# Service

**DDC EXHAUST ROCKER ARM ADJUSTING SCREWS**

**PACBRAKE ENGINE BRAKES P-61 / P-63 / P-63A  
P-63B / P-63C / P-80 / P-80A**

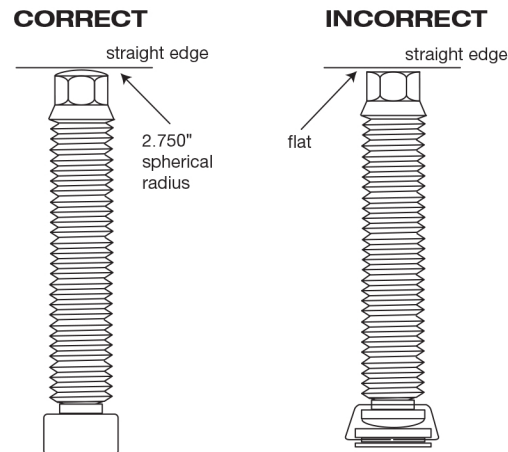
Detroit Diesel Corporation has reported that exhaust rocker arm adjusting screw part number 8929646 is not for use in Series 60 engines. An undetermined quantity of these screws were released into the field, so please check all the exhaust adjusting screws in the engine prior to installing the engine brake housings.

The difference between the correct and the incorrect exhaust adjusting screw is the end provided for the engine brake slave piston to contact. The correct screw has a 2.75" spherical radius for the slave piston contact surface. This spherical radius prevents side loading of the slave pistons during engine brake operation. The incorrect screw has a flat contact surface and is designed for industrial applications that do not use an engine brake. Installing engine brake housings on an engine with any of the incorrect exhaust adjusting screws **will** result in slave piston bore wear causing poor engine brake performance.

How to check for the 2.75" radius, use a straight edge across the top end of each screw as shown.

At time of this printing the correct Detroit Diesel adjusting screw part number is 23520819.

January 2012, superseded to 23537089.
